STAFF REPORT ADDENDUM

APPLICATION RZ/FDP 2015-HM-012
Concurrent with
DPA-HM-117

PROPOSAL: To rezone 4.6 acres from the I-5, R-E, and PRC Districts to the PDH-12 District to permit a residential development for 34 single family attached dwelling units and 10 multifamily dwelling units.

Figure 1- Inset of Updated CDP/PCA/DPA Plan Set with Notations and Updated Garage Plan

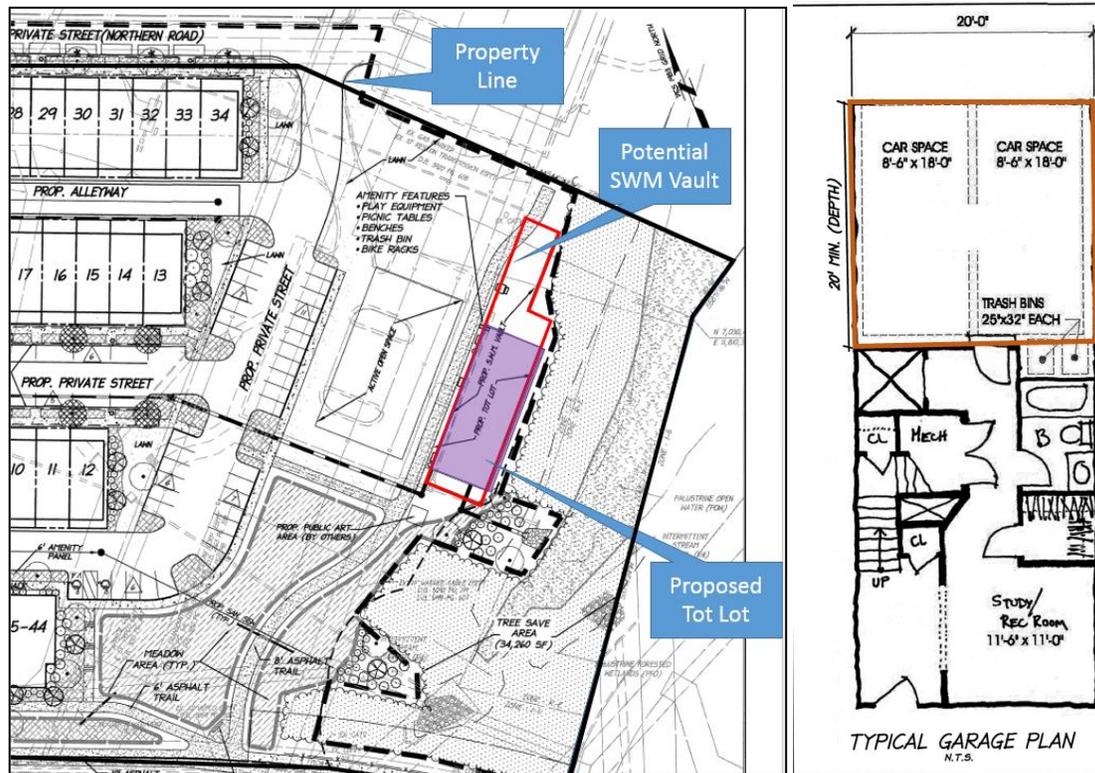
Since the original hearing date on May 5, 2016, the applicant has updated the CDP/FDP/DPA Plan, a copy of which is included in the front of this report. The applicant has made the following revisions:

- Sheet 1, Note 31 - The applicant added a note that outlined the location of the HVAC units on top of the dwellings
- Sheet 5 - The applicant added the potential location of a stormwater management facility underneath the tot lot and an associated proffer was added
- Sheet 7 - The applicant increased the depth of the garage by one foot; therefore increasing the interior size of the garages from 19 feet by 19 feet to 20 feet by 19 feet.
